TOWN OF CARMEL
PLANNING BOARD

PLANNING BOARD AGENDA
JANUARY 24, 2024 – 7:00 P.M.

Re: **RESPONSE TO CONSULTANT COMMENTS**
TTSHR LLC, formerly Lamorte
25 & 27 Seminary Hill Road, TM # 55.6-1- 69 & 70

SEMINARY HILL ROAD
LIGHTING PLAN
1" = 40'

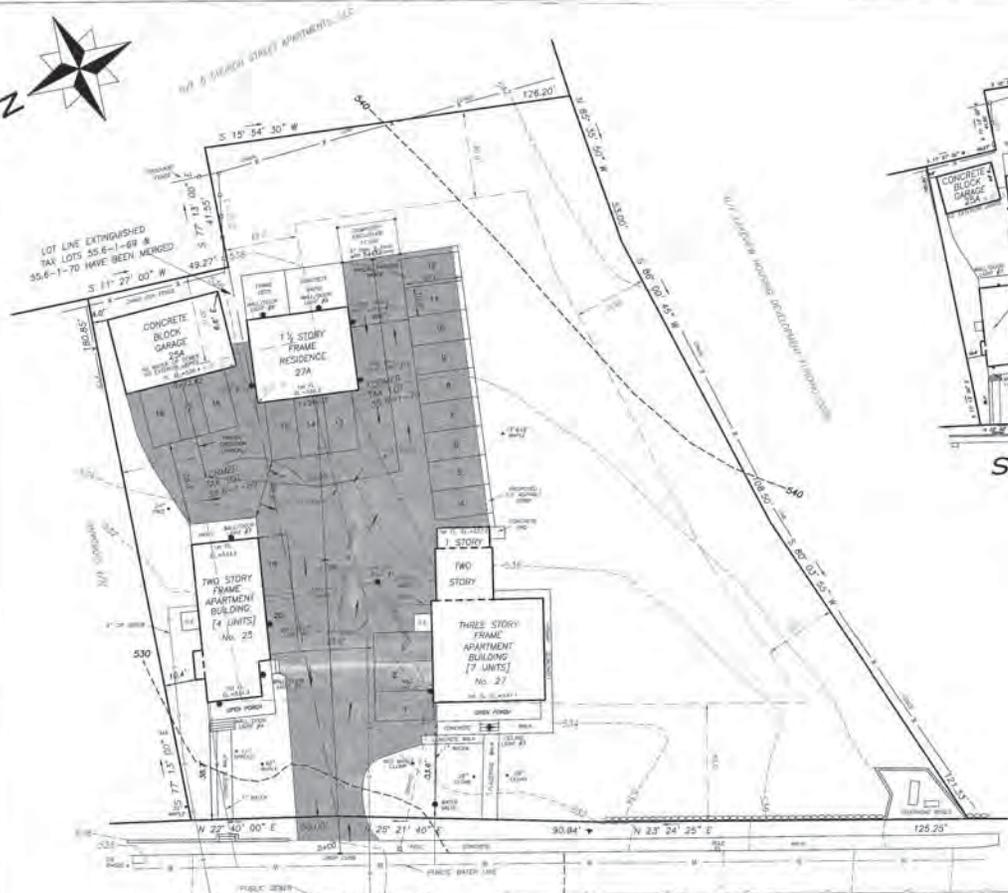
- The open space has been evaluated with respect to the standard of 300 square feet per dwelling unit. Based upon 12 units, the required open space is 3600 square feet. The box on the “Lighting Plan Map” indicates 11,400 square feet.
